SUBJECT: EXPANDED OPERATING DOMAIN (ARTS/MELLLA) TECHNICAL SPECIFICATIONS,
PEACH BOTTOM ATOMIC POWER STATION, UNIT 3 (TAC NO. M86133)

PEACH BOTTOM ATOMIC POWER STATION, UNIT NO. 3

Amendment No. 184
License No. DPR-56

ATTACHMENT TO LICENSE AMENDMENT NO. 184

Figure 1.1-1

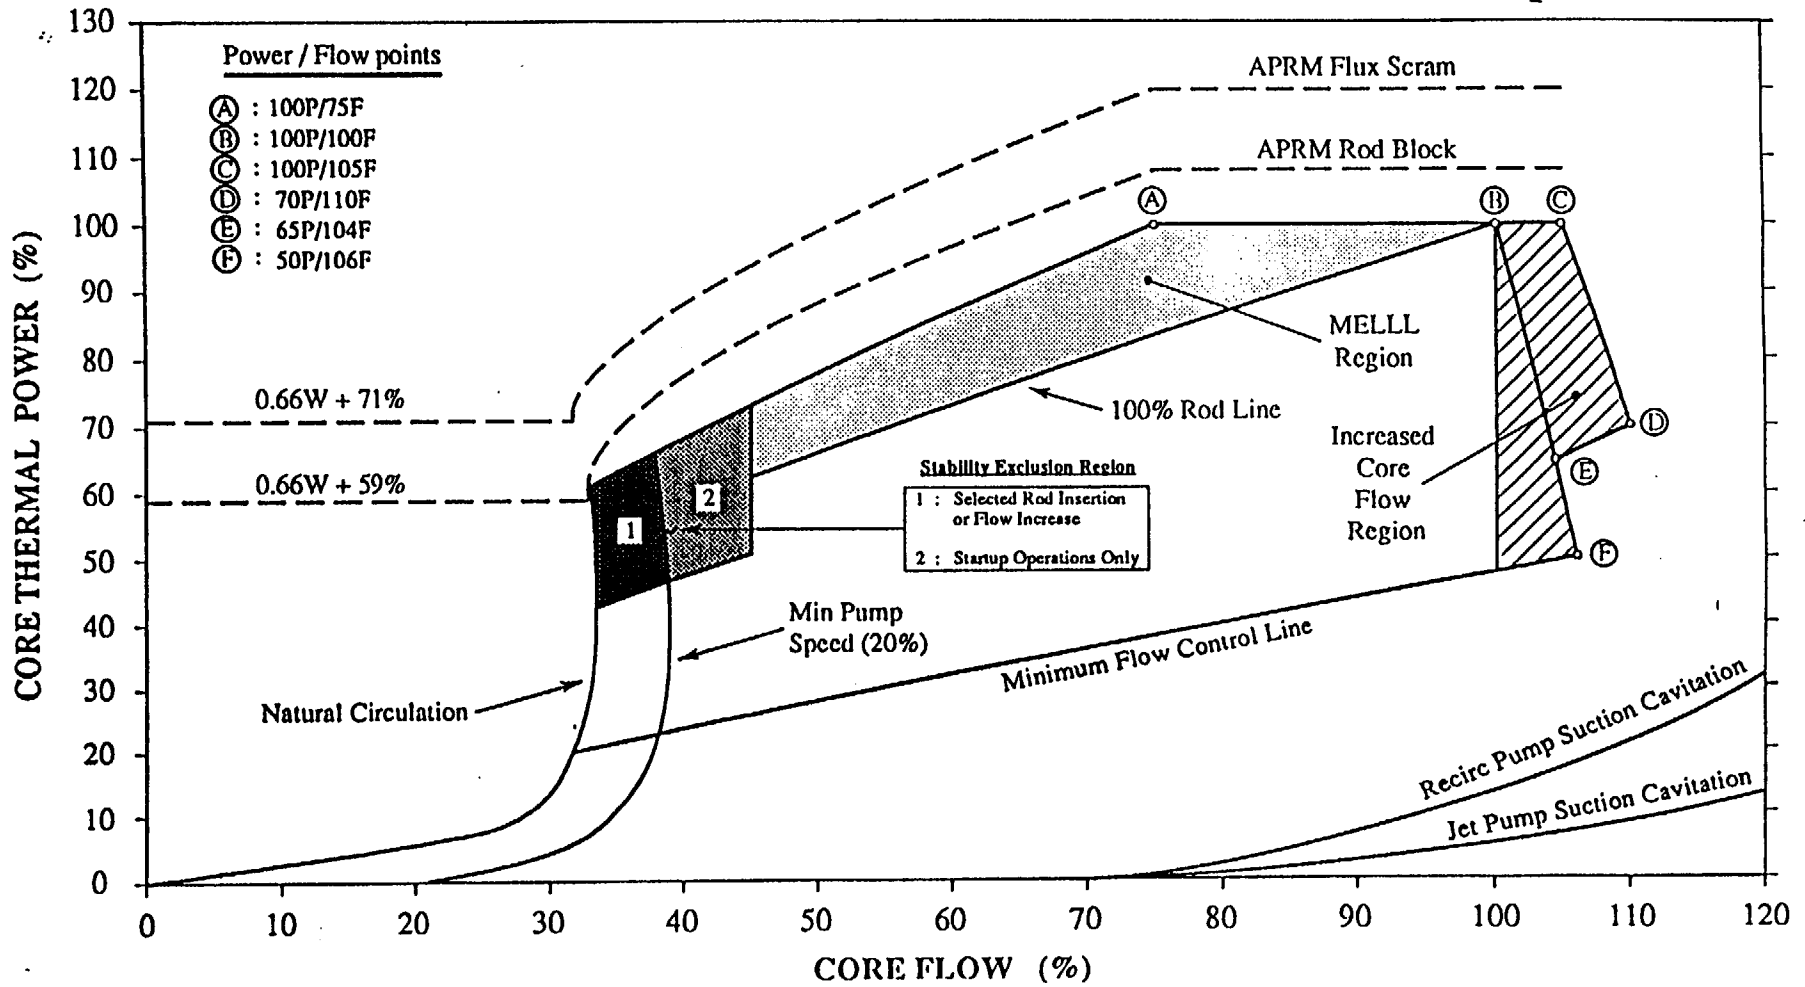
- d. Figure 1.1-1, entitled, "APRM Flow Bias Scram Relationship to Normal Operating Conditions," (the power-to-flow operating map) is revised to include the MELLLA region and the updated APRM limits.
